Parallel Configuration User Manual

Document Update

Publication 2364P-5.01DU1 - March 2000

Figure 1
Updates to RGU Schematics—Parallel Configuration

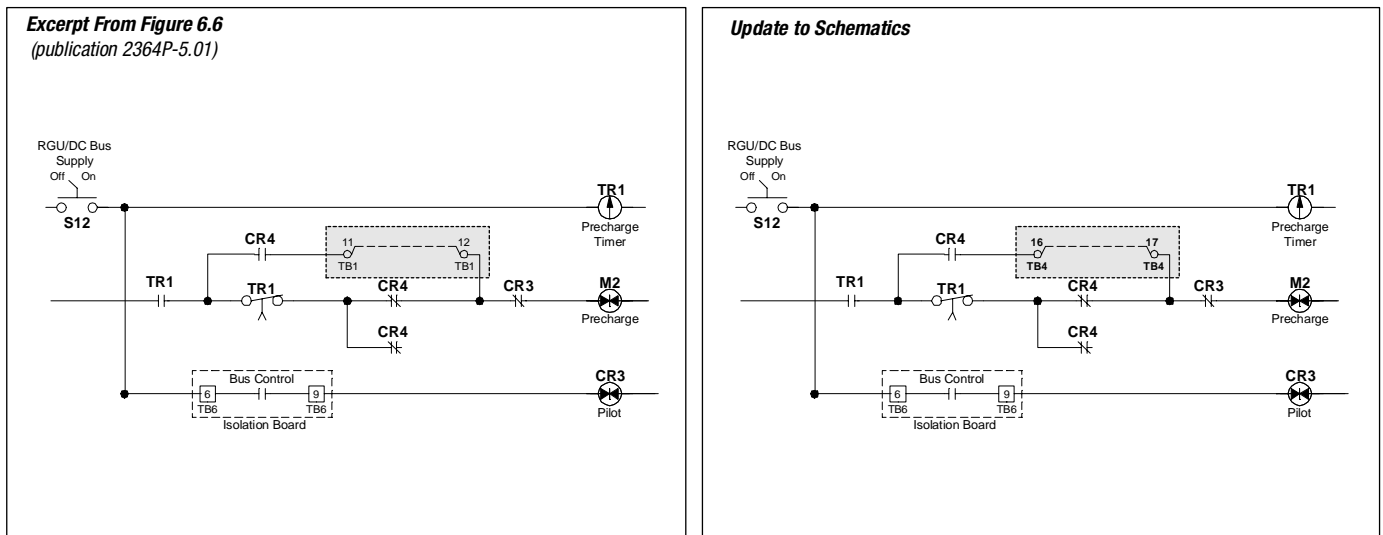
The following terminal block descriptions should be updated for all RGU control circuitry schematics shown in the parallel configuration manual.
